Analysis of Matrix Heat Exchanger Performance¹

V. Ahuja² and R. K. Green³. Recently, a new numerical scheme for solving the equations governing matrix heat exchanger thermal performance was published in this journal. It was found that this scheme does not include the full effect of longitudinal heat transfer in the said heat exchangers. This effect is demonstrated by correcting the parameter related to longitudinal heat transfer in the approximate analytical solution for the balanced flow case and finding it to deviate considerably from the numerically calculated result.

Review

Fig. 1 Perforated plate and spacer dimensions

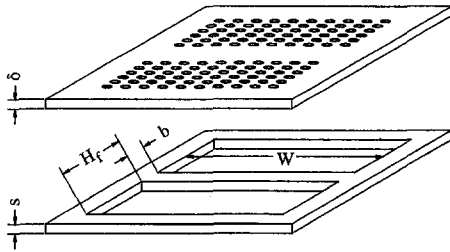
The control volume for which the energy balance is considered for deriving the governing equations does not include the area over which longitudinal conduction occurs other than the separator. The axial conduction parameter defined in Eq. (3) incorporates a spacer area equivalent only to that of the separator (bW). The parameters λ_p and $\lambda_s = n\lambda$ are derived from the energy balance for the separator, for the numerical solution. Venkatarathnam has then applied λ to the approximate analytical solution as the overall axial conduction parameter to account for axial conduction as done by Kroeger (1969). However, Kroeger has used the overall axial conductivity and total area for axial conduction to define this axial conduction parameter λ as

The walls of the perforated plate matrix heat exchanger are formed by bonding a stack of alternating low thermal conductivity (plastic/stainless steel) spacers and copper perforated plates to form a monolithic block (Fig. 1). The walls that separate the streams from the environment and that which separate the two streams are thus interconnected. In deriving the governing equations, it was assumed that the longitudinal heat conduction occurs only through the walls that separate the streams, to simplify the analysis. This assumption has been made by many workers (Kroeger, 1967) who have studied the performance degradation due to longitudinal heat conduction through the walls of heat exchangers. These assumptions are meant only to simplify the analysis and make the problem tractable. While analyzing the performance of any real heat exchanger it is necessary to take the longitudinal heat conduction through all the walls. In most cases, the performance of the heat exchanger will be slightly underpredicted if the longitudinal heat conduction through the outer walls is accounted for by adding the cross-sectional areas of the outer and inner walls, and assuming that all the longitudinal heat conduction occurs only through the inner wall alone (Narayanan, 1997).

It is well known that the longitudinal heat conduction parameter should be estimated using the area of all the walls of any exchanger, including perforated plate matrix heat exchangers. To demonstrate the basic principles of heat exchangers, Mills (1996) used the total foot print area to evaluate the longitudinal heat conduction parameter and predict the performance degradation due to longitudinal heat conduction in perforated plate heat exchangers. Thus, the suggestion made by Ahuja is not new.

Fig. 2 Ntu_{eff} versus Ntu_D for a: Venkatarathnam, analytical; b: Venkatarathnam, numerical; c: analytical, using λ from (8); d: numerical, using λ from (8); e: analytical solution using Fleming's (1969) equation for fin effectiveness and Kroeger's method for longitudinal conduction

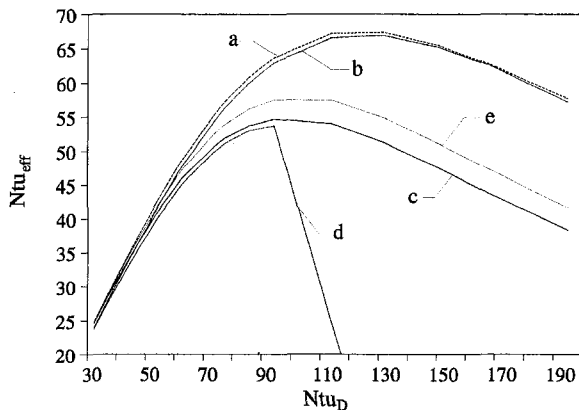
Venkatarathnam's use of λ thus represents a small proportion of the area over which axial conduction occurs, and the net axial conductivity. The effect of taking λ from (3) or (8) is shown in Fig. 2.

Venkatarathnam's results were presented as Ntu_{eff} versus Ntu_D graphs for constant ϕ and λ . A matrix heat exchanger of given geometry at one flow condition would represent a single point on such a graph. Figure 2 shows Ntu_{eff} versus Ntu_D plotted for given constant geometric parameters. Venkatarathnam's ap-

proximate analytical and numerical solutions only show agreement provided λ is calculated for the separator alone. If λ is taken as the overall axial conduction parameter, the approximate analytical solution deviates considerably from the numerical solution. As to whether the numerical solution can take into account axial conduction in the heat exchanger body other than in the separator is uncertain.

Fig. 3 Ntu_{eff} versus Ntu_D for a: Venkatarathnam, analytical with $\lambda_p = \infty$; b: this work, with finite values for λ_p ; c: Venkatarathnam, numerical; d: analytical solution using Fleming's equation for fin effectiveness and Kroeger's method for longitudinal conduction

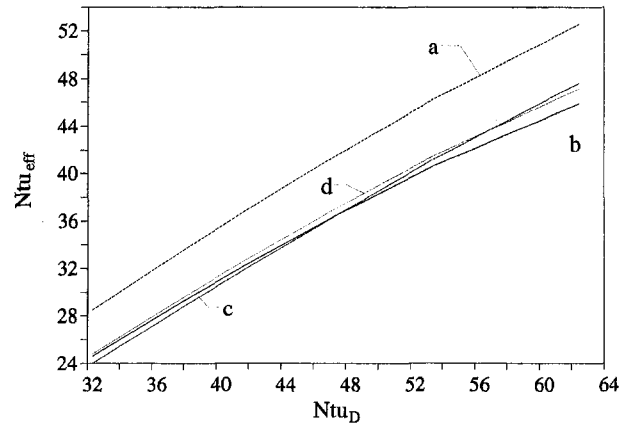
The effect of taking $\lambda_p = \infty$ is shown in Fig. 3. The convection heat transfer coefficients for the matrix heat exchanger are much higher than those normally associated with gaseous heat transfer media. It is apparent that the simplification of $\lambda_p = \infty$ may not

be justifiable for the low Reynolds number flows which are characteristic of matrix heat exchangers.
